## Product Change Notice (PCN)

**PCN Number:** PCN-0451176R-01

Product(s) Affected: *PJ-046, PJ-046H*

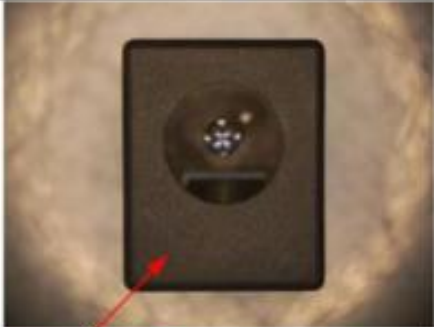
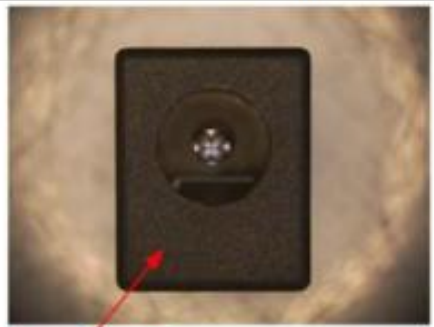
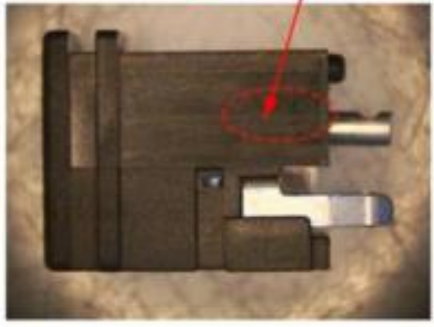
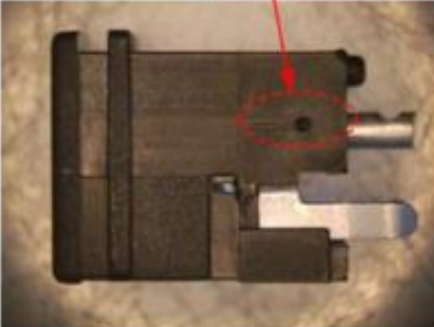
Description of Change: *Photos of changes included below. PJ-046H center pin (pin 1) is changed from nickel plating to silver plating.*

**Comparison plastic housing as below:**

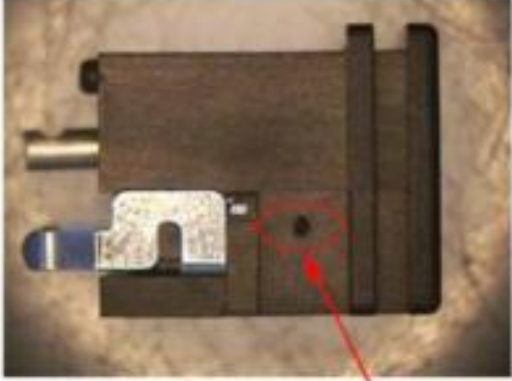
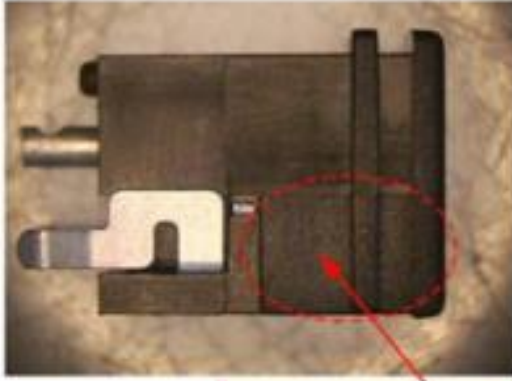
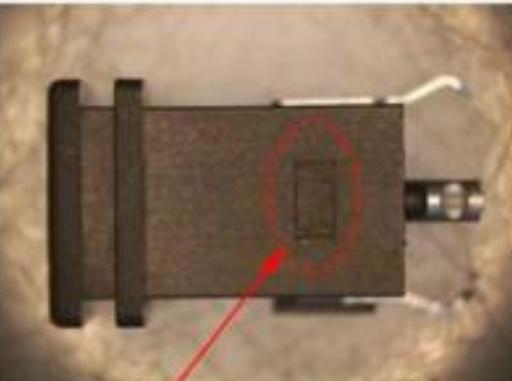
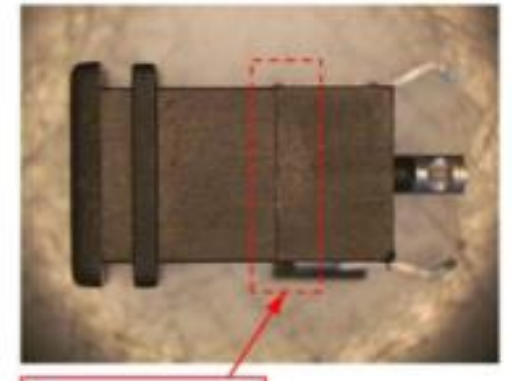
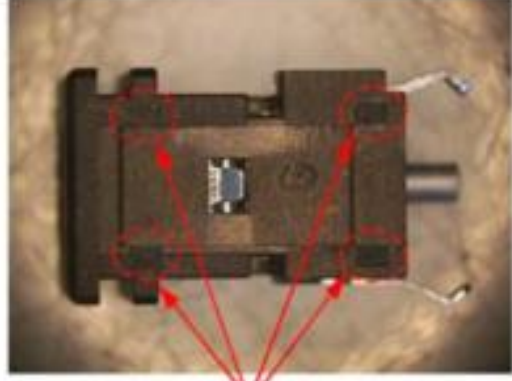
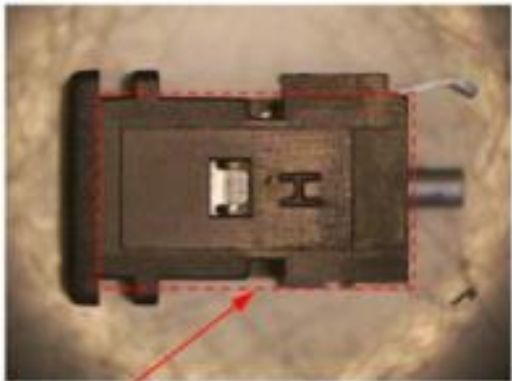
<b>New version</b>	<b>Current version</b>
<b>Front</b>	 <p>smooth surface</p>	 <p>rough surface</p>
<b>Back</b>	 <p>outlook different</p>	 <p>outlook different</p>
<b>Left</b>	 <p>smooth surface</p>	 <p>injection point</p>

<p><b>Right</b></p>	 <p>injection point</p>	 <p>rough surface</p>
<p><b>Top</b></p>	 <p>outlook different</p>	 <p>outlook different</p>
<p><b>Bottom</b></p>	 <p>outlook different</p>	 <p>outlook different</p>
